# STAFF RECOMMENDATION

NCPC File No. ZC 03-12G,H/03-13 G,H

## MODIFICATIONS TO SECOND STAGE PLANNED UNIT DEVELOPMENT CAPPER/CARROLLSBURG HOPE VI REDEVELOPMENT PROJECT FOR SQUARES 882 AND 769

Southwest  
Washington, DC

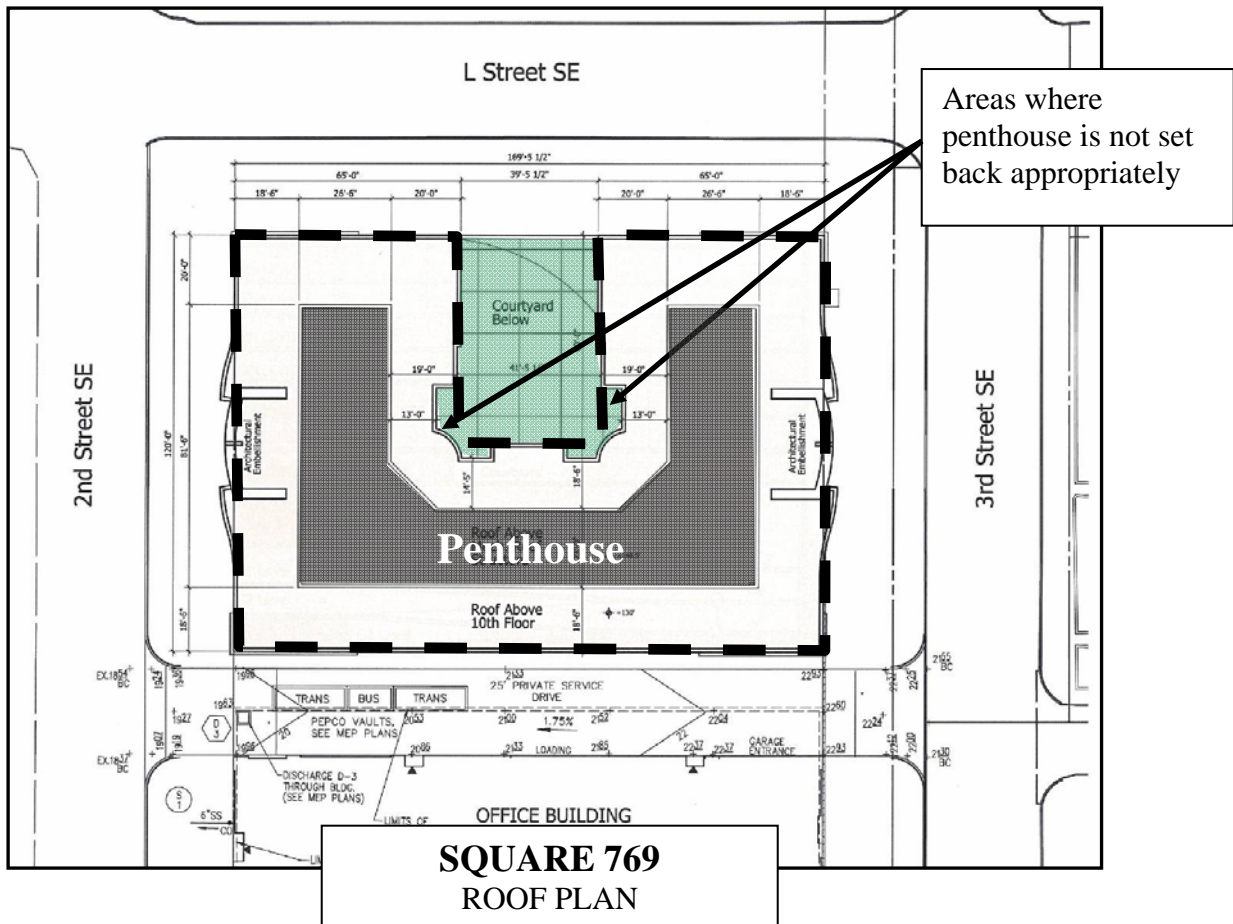
The penthouse on the proposed residential building on this Square is set back properly from exterior walls facing streets, but is not set back from all portions of exterior walls as required by the Height Act. This is illustrated in the roof plan below which identifies the back corners of the walls of the second floor courtyard where the set back is not adequate.

While this design is not in accordance with the provisions of the Height Act, in this instance staff is not recommending that the Commission comment unfavorably because the portions of the penthouse that are not properly set back will not be visible from the street or other publicly accessible location, and the courtyard itself is not public, being accessible only from the building's second floor.

ENCLOSURE 1: ZONING MAP OF M STREET SE AREA

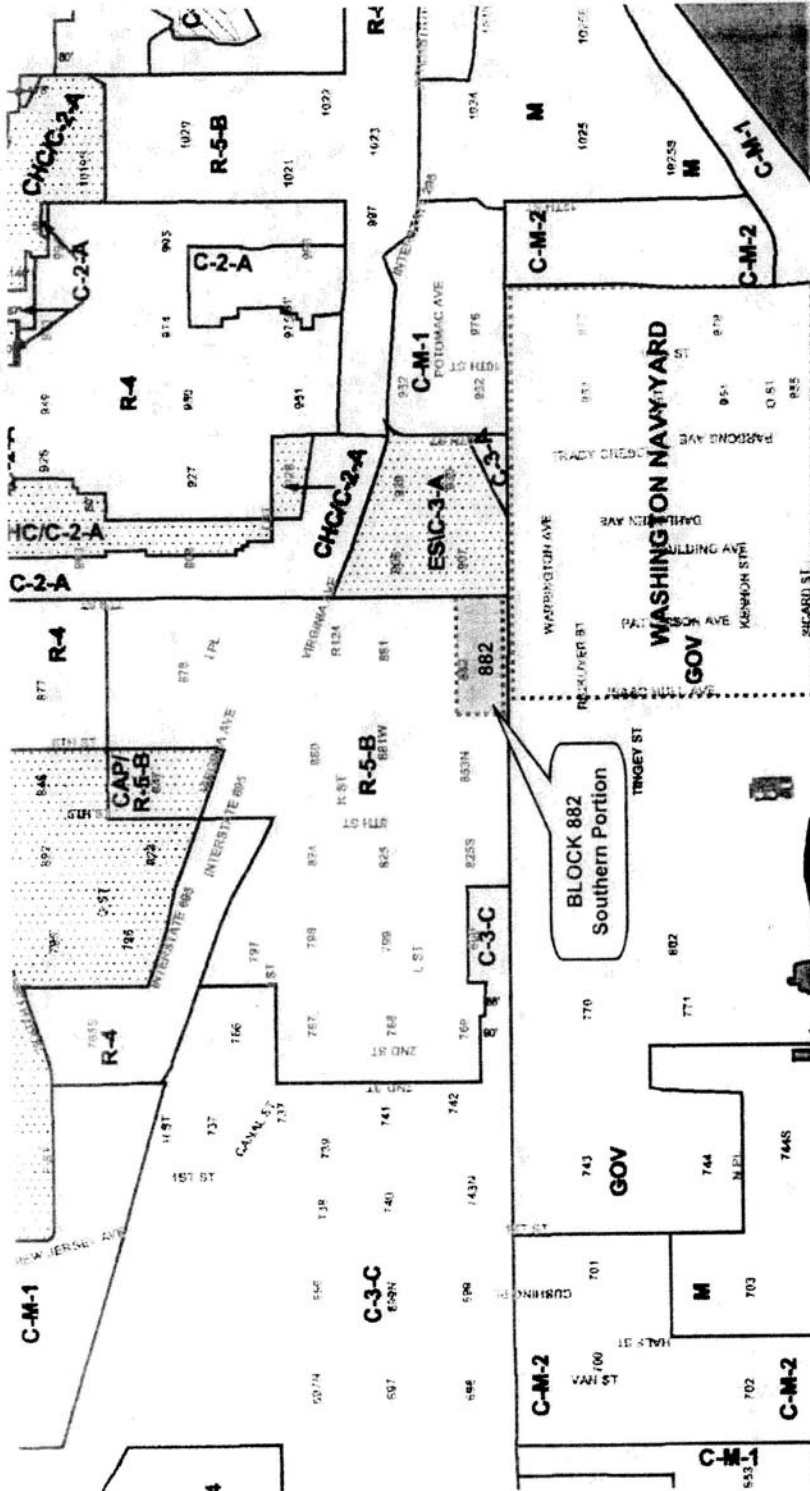
Naval Support Activity Washington has some significant concerns regarding the re-zoning of the areas indicated on the enclosed Zoning Map of M Street area from your website at <http://dcoz.dc.gov/services/zoning/commish.shtm>

We request that the record be reopened to accept filing of our comments to the public record in reference to zoning cases 03-12G and 03-13G. The current R-5-B zoning for the southern half of Square 882 limits the building height to a maximum height of fifty (50) feet. The District's conditional approval rezoning the southern portion of Square 882 to the CR zoning designation, by Zoning Commission Order Number 03-12G/03-13G, would allow a maximum height restriction of ninety (90) feet. The current application for the Second Stage Planned Unit Development (PUD) further requests an increase in height for the southern portion of Square 882 to a maximum height of ninety-two (92) feet. As proposed, the rezoning would allow buildings on the southern half of Square 882 be increased to a height of ninety-two (92) feet where presently the height is limited to fifty (50) feet. The Navy opposes the proposed height provisions of this amendment for the following two reasons:
